**From:** Milam, Kaylie  
**Sent:** Wednesday, March 25, 2020 8:37 AM  
**To:** Nestegard, Haley  
**Subject:** FW: [EXTERNAL] Re: Re: Re: Re: Re: Re: UPRR 38 PA O TRUE 2 (API: 05-123-11055) GO-BACK

**From:** Jacobson - DNR, Eric <eric.jacobson@state.co.us>  
**Sent:** Friday, February 14, 2020 9:17 AM  
**To:** Mary\_Milam@oxy.com  
**Subject:** [EXTERNAL] Re: Re: Re: Re: Re: Re: UPRR 38 PA O TRUE 2 (API: 05-123-11055) GO-BACK

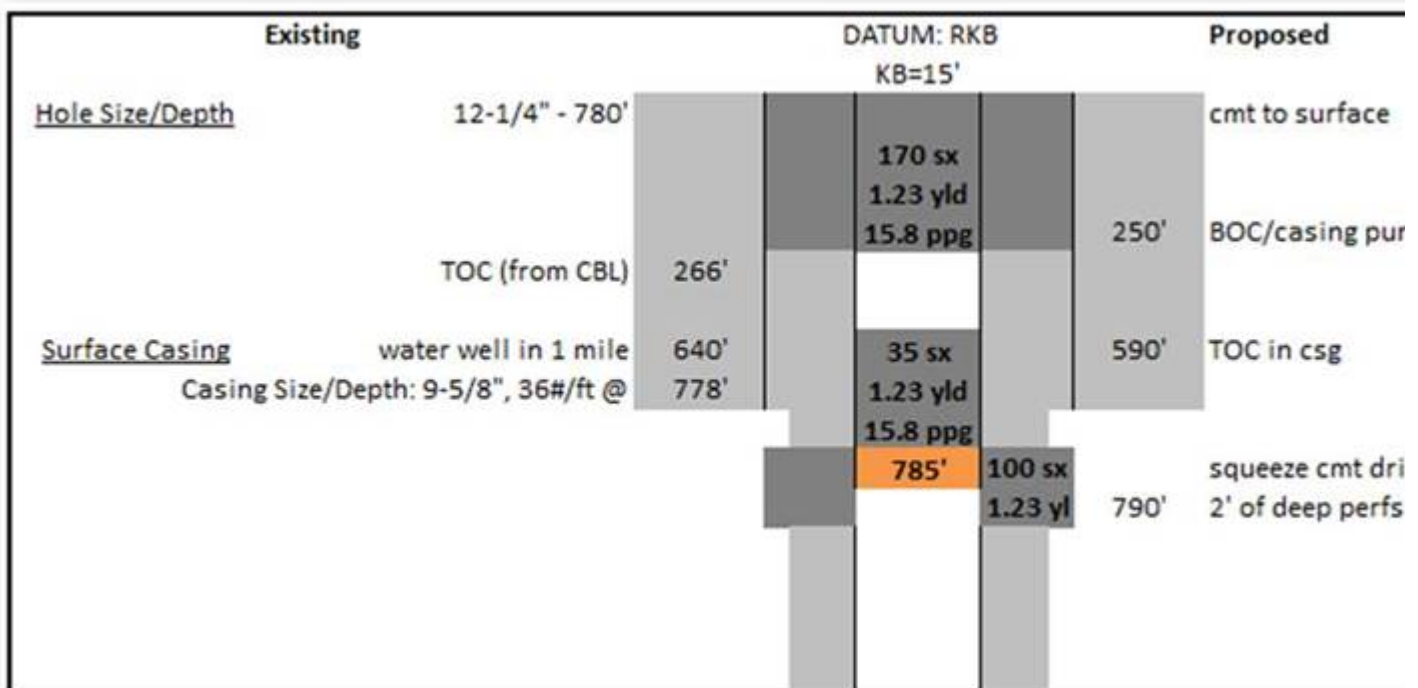
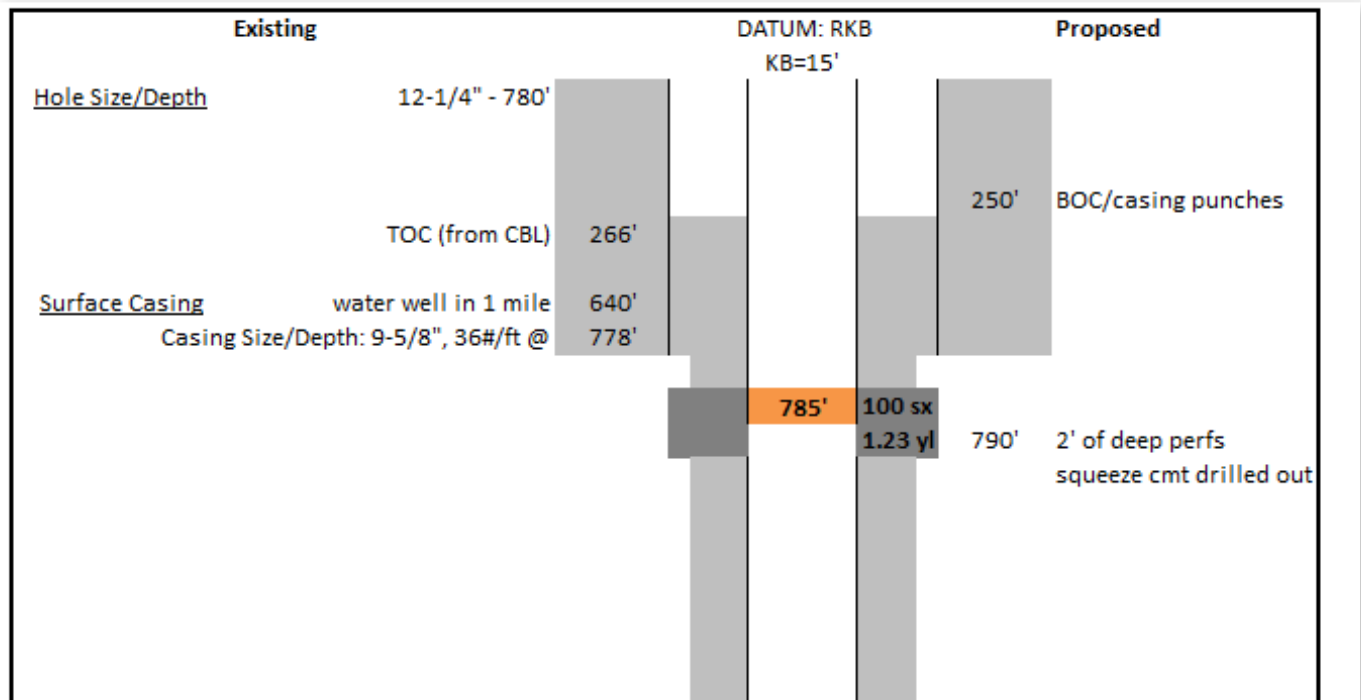
Yesterday, we set the CIBP at 785' to provide isolation for the squeeze holes shot at 790'.

This morning we have no signs of fluid or gas migration, with 0 psi and no LELs.

We plan to proceed by topping the CIBP with 35 sx cement and continuing to circulate cement inside and outside casing from 250' to surface.

**Current**

**Planned**

Approved as outlined.
